Review of SA Water Supply Mix optimisation

3603-83

Prepared for
Essential Services Commission of South
Australia

May 2013

Figure 3-4 HOMAxp Pump Cost Curve (May, June July August)

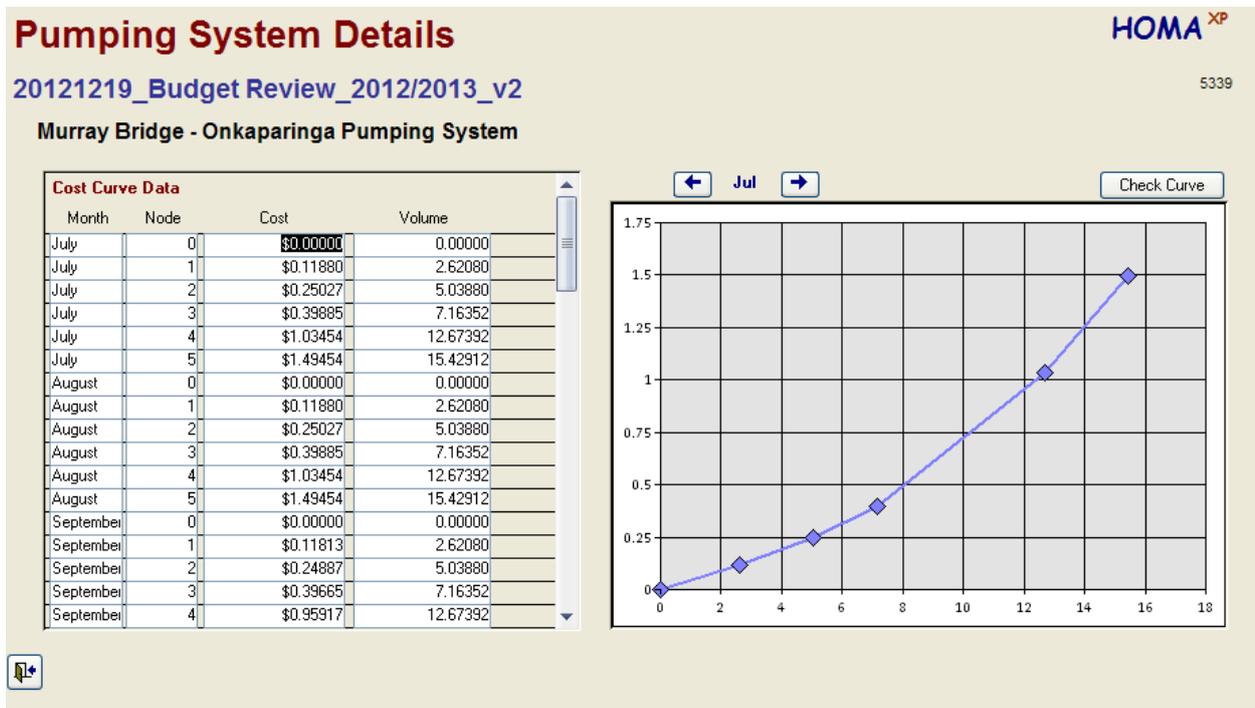
A flat rate for variable energy use would result in a linear cost function if there was also a linear relationship between the volume transferred and energy usage. However, generally, increased pumping to transfer increased volumes will lead to pumps having to be operated outside of their most efficient range and increased friction losses in pipelines and therefore increasing unit costs per volume transferred. The shape of the cost curve shown is consistent with this relationship.

However, the cost curve crosses the y-axis at zero unit cost suggesting that there is no charge when no water is pumped. This does not reflect the reality of SA Water’s electricity charges which include in reality fixed charges regardless of the volumes pumped. Inclusion of these fixed charges would logically lead to the cost curve crossing the y-axis at a positive number.

Therefore, while the shape of the cost function appears to reflect the operating environment, it appears that the cost curve does not reflect the fixed charges SA Water has to pay. As a result, the model is likely to underestimate the cost of pumping water (from the River Murray) and therefore possibly ‘overuses’ this source in preference to other sources. This ‘overuse’ would logically occur within the model until the marginal cost of supply from the River Murray matches the marginal cost of supply from the MLR reservoirs.

Figure 3-5 HOMAxp WTP Cost

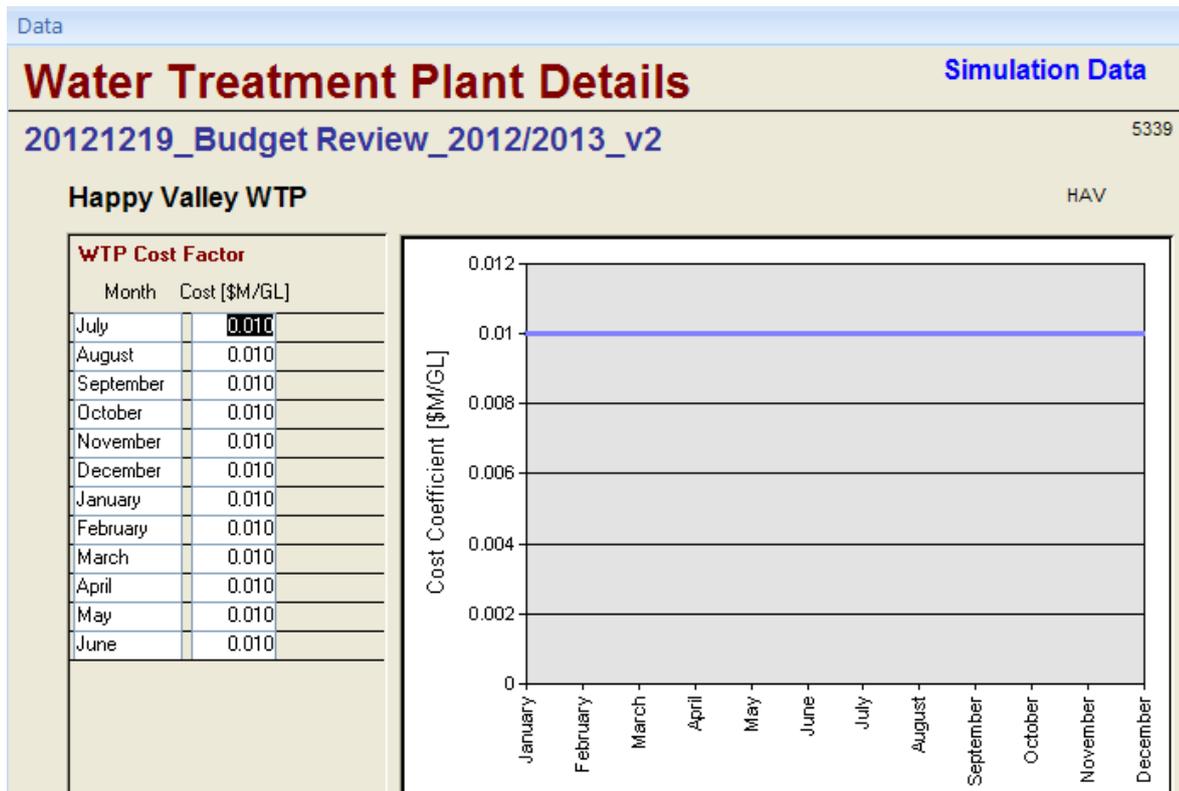
Comparing Table 3-2 and Figure 3-5, it is clear that the WTP costs used in HOMA are not actual costs as there is approximately a factor of ten difference between the costs of each [REDACTED] which cannot be explained by the absence of indirect costs. It is noted in the HOMA model documentation and by SA Water that it is sufficient that the costs functions (for all costs, e.g. pumping, WTPs, etc.) in HOMA are correct relative to each other rather than being absolutely correct. This is true, but there is no indication in the evidence that we have seen that the cost functions are relatively correct given that they are not absolutely correct either.

However, it appears that the cost function for WTPs included in HOMA play little or no role in determining the optimised bulk water supply mix. This is because of the way in which the model is configured with a WTP given a fixed demand to meet each month as described in Section 3.2.4. Therefore, there is no ability for HOMA to choose a lower cost water treatment plant over a higher cost water treatment plant to result in a lower total cost of supply. Network constraints and proximity will mean that there is a limit to the extent to which each water treatment plant can supply the 'designated' supply region of another treatment plant. Nevertheless, we consider this rigid assumption a significant limitation on the ability of HOMA to determine a least cost mix of supply sources. This is reinforced by the recent commissioning of the North-South Interconnection System which provides greater flexibility for SA Water to transfer water between supply zones.
